Drainage Letter Report

1875 MAIN STREET
COLORADO SPRINGS, COLORADO
80911

February 15, 2019

Add PCD File No. PPR198

EX1 DEVELOPED SUB-BASIN DELINEATION EXHIBIT
1" = 30'-0"

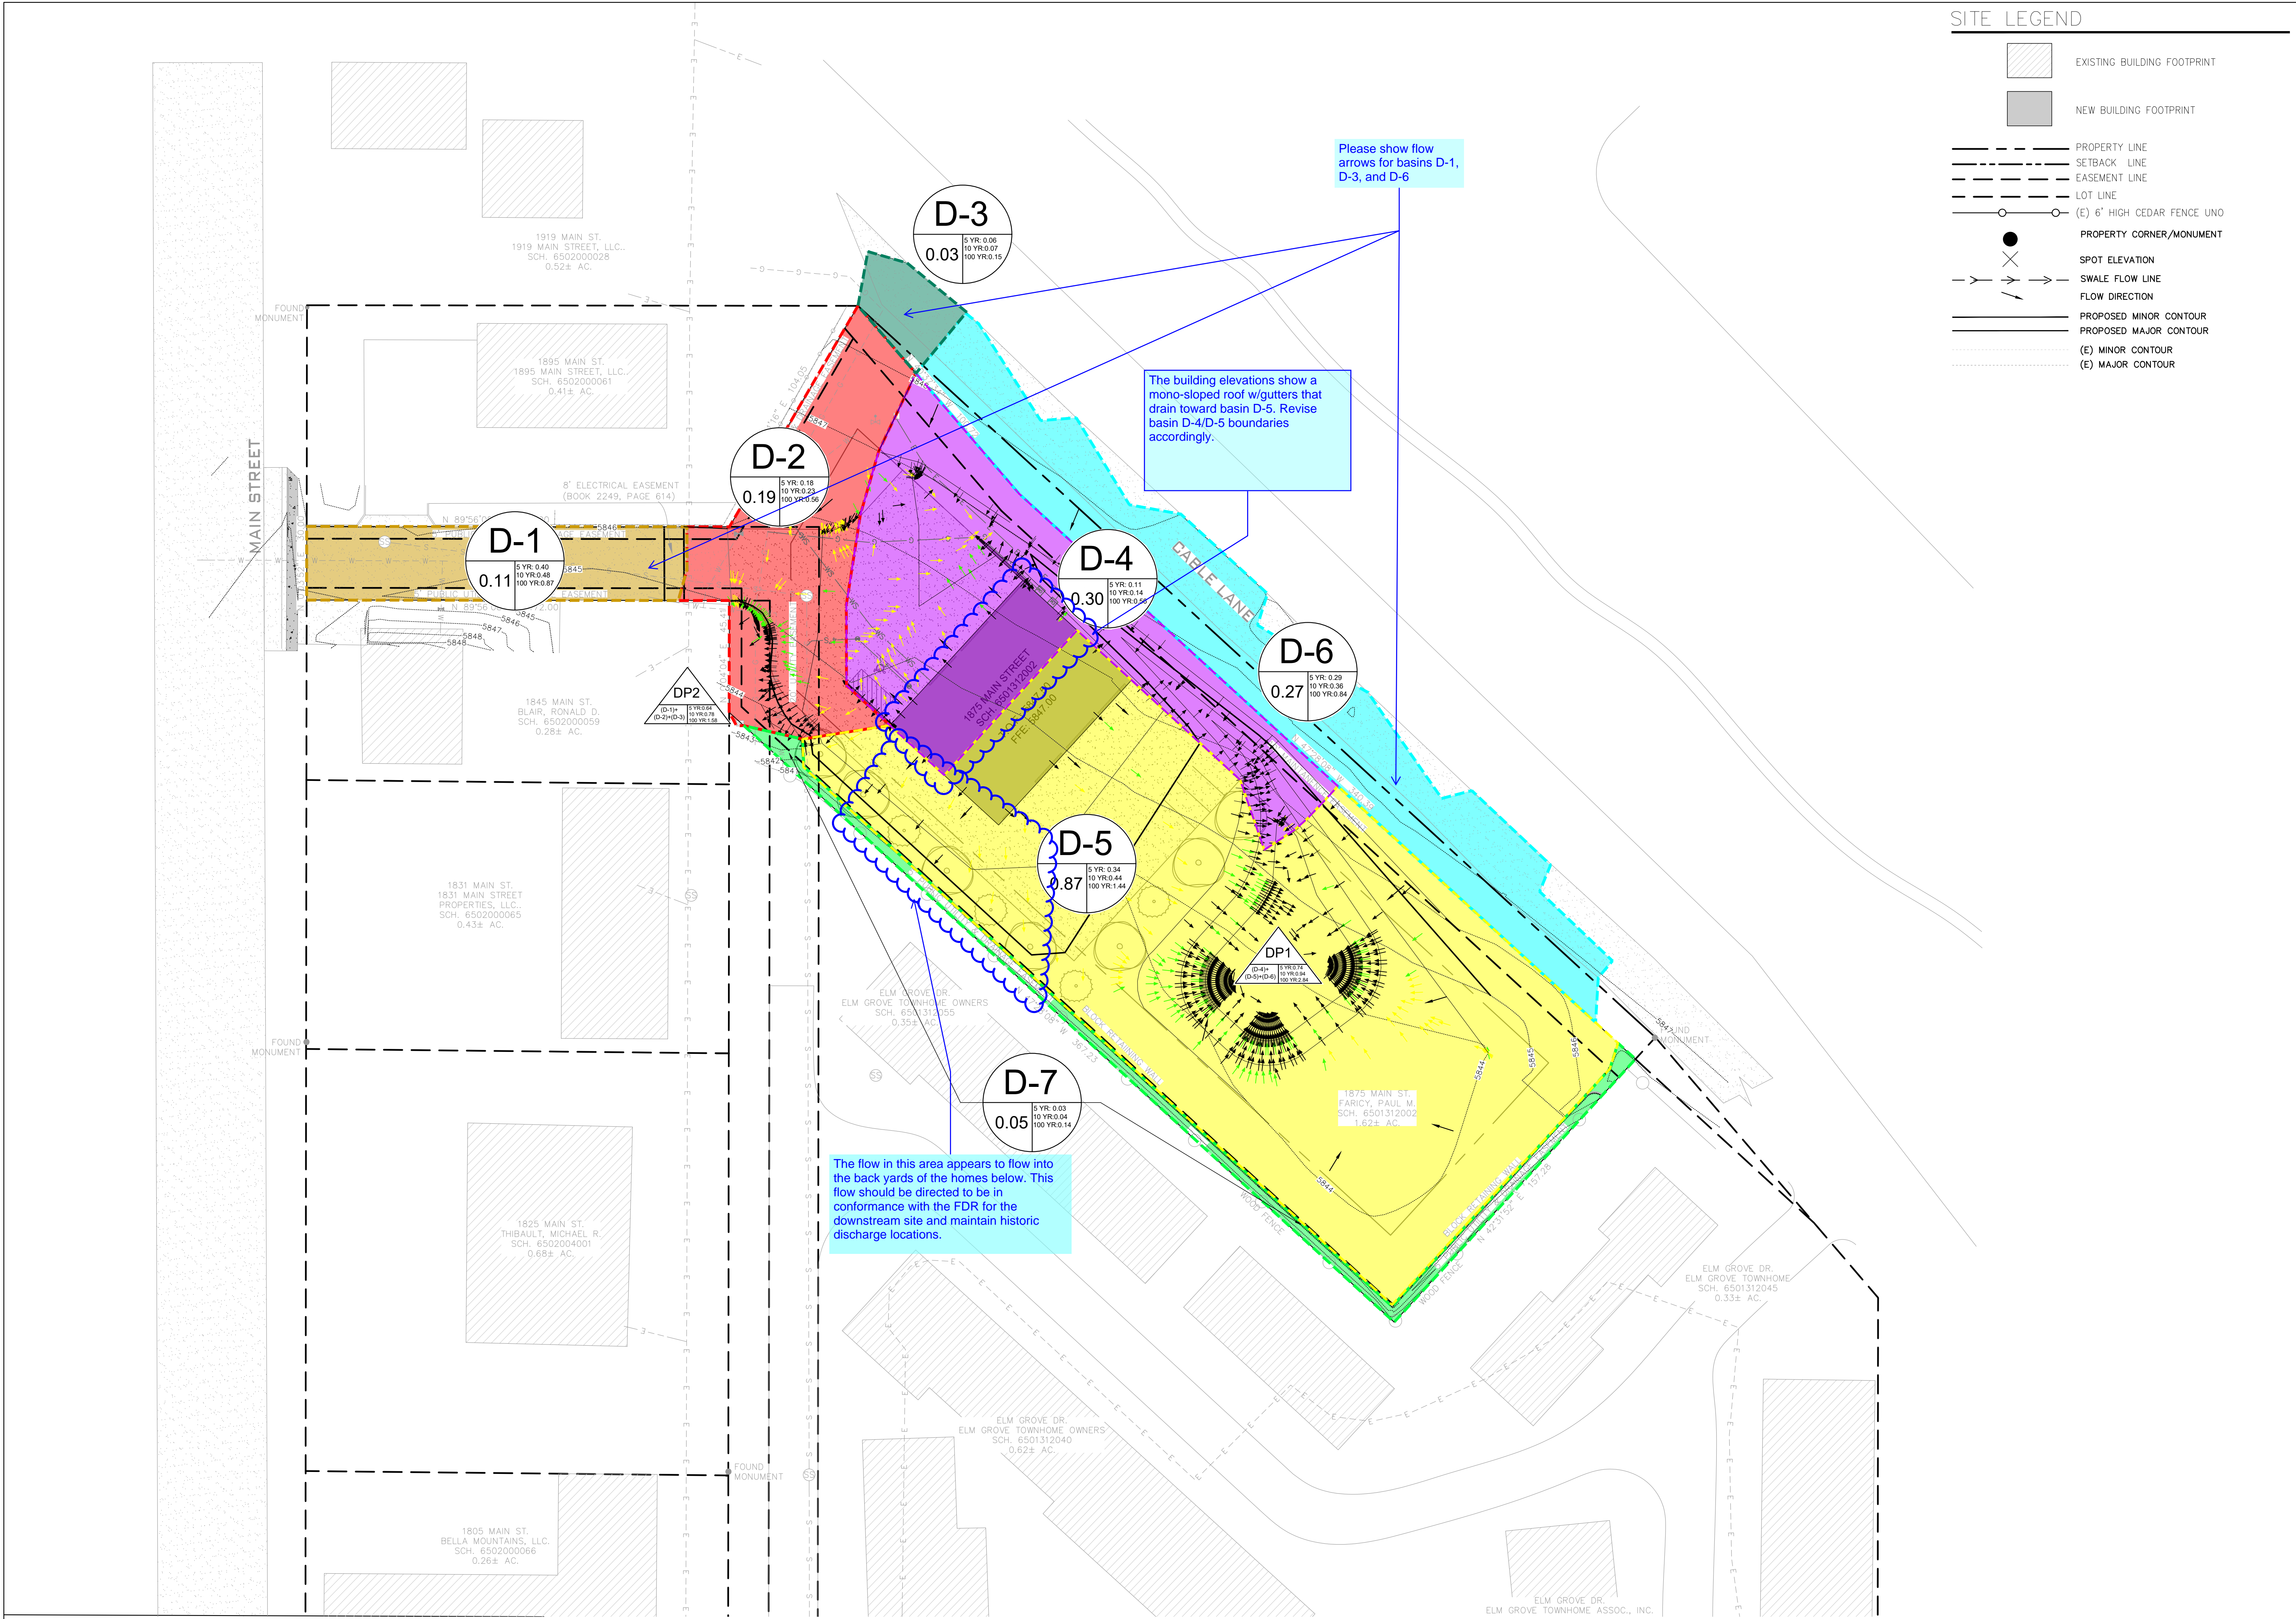
Please show flow arrows for basins D-1, D-3, and D-6

The building elevations show a mono-sloped roof w/gutters that drain toward basin D-5. Revise basin D-4/D-5 boundaries accordingly.

EX2 EXISTING CONDITIONS SUB-BASIN DELINEATION EXHIBIT
1" = 30'-0"

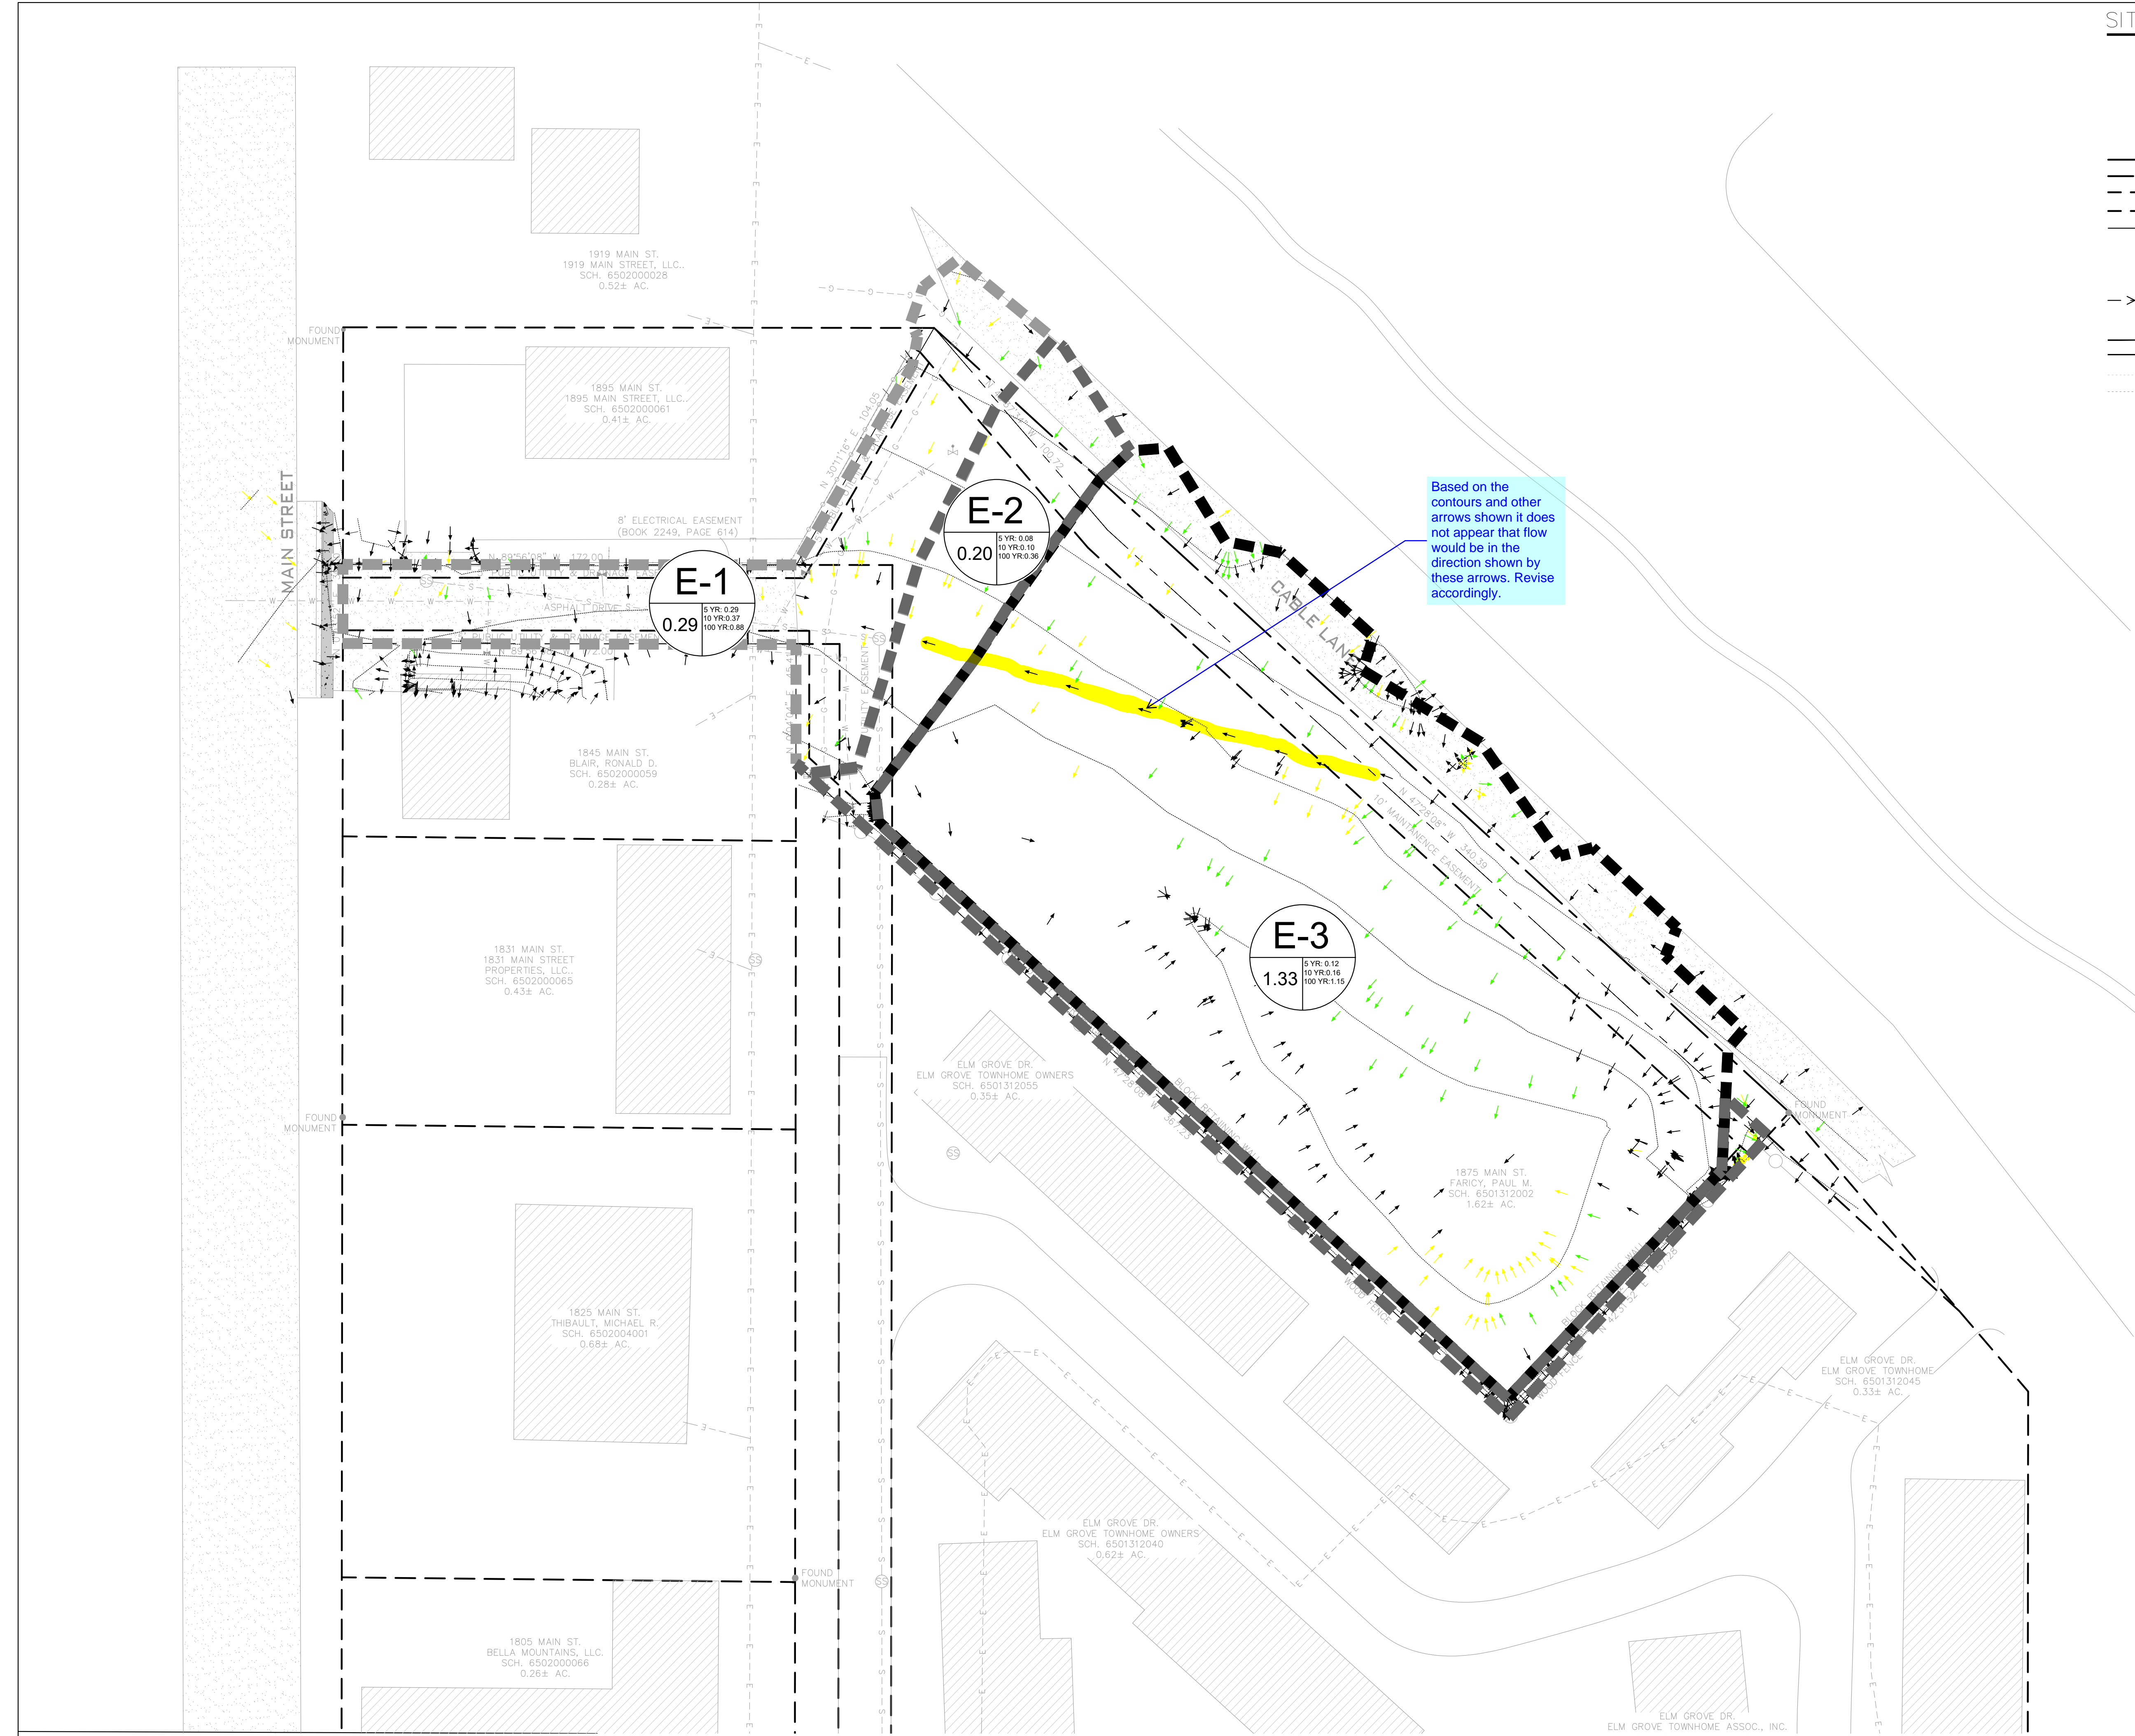
Based on the contours and other arrows shown it does not appear that flow would be in the direction shown by these arrows. Revise accordingly.
